In the matter of
Pacific Gas and Electric Company
Diablo Canyon Nuclear Power Plant
Units 1 and 2

Docket Nos. 50-275-LR
50-323-LR

DECLARATION OF PETER BIRD, Ph.D

Submitted to the U.S. Nuclear Regulatory Commission
By San Luis Obispo Mothers for Peace, Friends of the Earth,
and Environmental Working Group

**Mark-up (in red) by P. Bird, 2023 of
Figure 13-17 of SSC for DCP
(PG&E, 2015)**

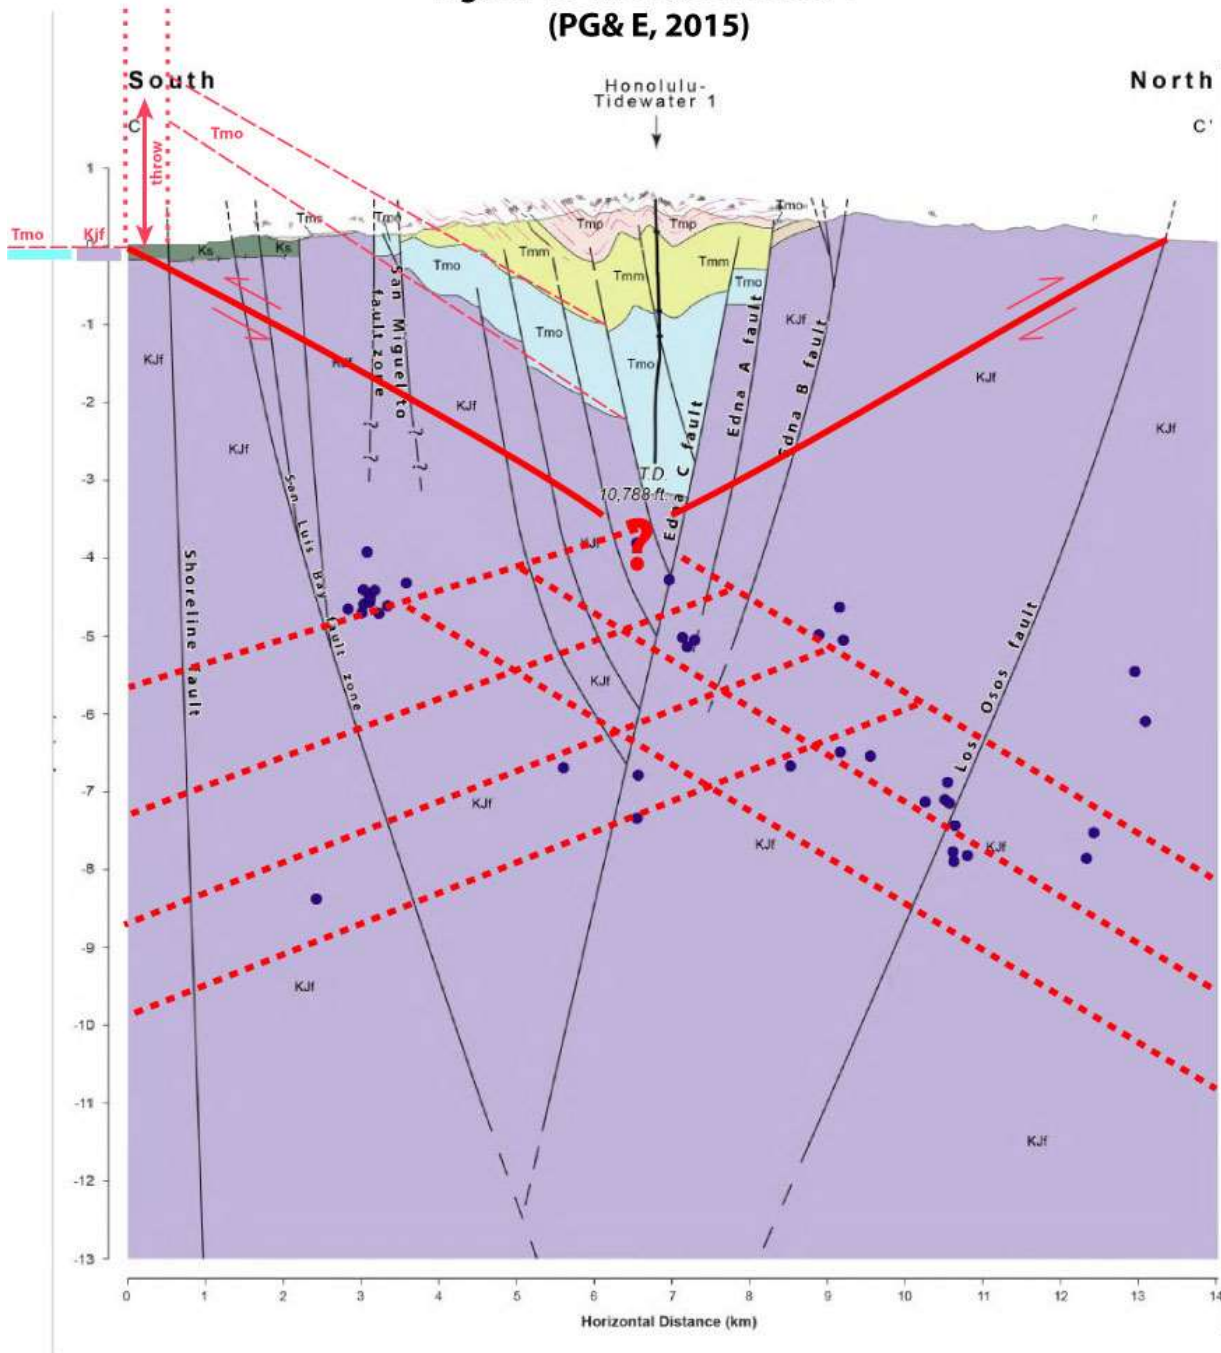
- b. According to the geologic map [PG&E, 2014] and associated cross-section C-C’ in its Fig. 13-17, the apparent throw (vertical offset) of stratigraphic unit Tmo Obispo Formation is 1.6~2.2 km across the Shoreline fault trace. (This measurement is illustrated in my own Figure 1.) None of this can be explained by strike-slip on the Shoreline fault because its slip-rate is very low and because regional strikes of bedding are roughly parallel to it. Instead, the simplest explanation is thrust-faulting on the Inferred Coastline thrust that shares the complex, braided surface trace of the Shoreline fault. Assuming a typical thrust-fault dip of 25°, the amount of slip required to create this throw is $(1.6\sim 2.2 \text{ km}) / \sin(25^\circ) = 3.8\sim 5.2 \text{ km}$. Then, assuming this occurred since ~5 Ma, the mean rate of slip on the Inferred Coastline thrust has been 0.76~1.04 mm/a. To the northwest of section C-C’ the throw of unit Tmo becomes much less, but the area of neotectonic uplift of the Irish Hills (Figure 7-4 in PG&E, 2015) continues to the northwest; so there the thrust fault probably does not terminate but merely deforms unit Tmo into a fault-initiation anticline above it. (In this area, complex older deformation associated with intrusions of Tmod diabase obscures the Pliocene-Quaternary structure, and makes balanced-section methods inapplicable.) In my professional judgment, this Inferred Coastline thrust fault continues, with the same rake and offset, northwest to the Hosgri fault.

Figure 1. Revised geologic section through the Irish Hills near DCP. The base for this figure is Figure 13-17 of the Seismic Source Characterization for DCP (PG&E, 2015). Note that the fault dips suggested by black lines in their figure were not based on data, but were constrained by PG&E's (2015) *a priori* assumption that only strike-slip tectonics is active in the area. In red, I have suggested more plausible 25° dips for the Los Osos thrust (at right/North) and the Inferred Coastline thrust (at left/South). The upper-left portion of this figure is also edited to show the throw (vertical offset) of map unit Tmo across the Inferred Coastline thrust, discussed in my text paragraph IV.B.25(b).
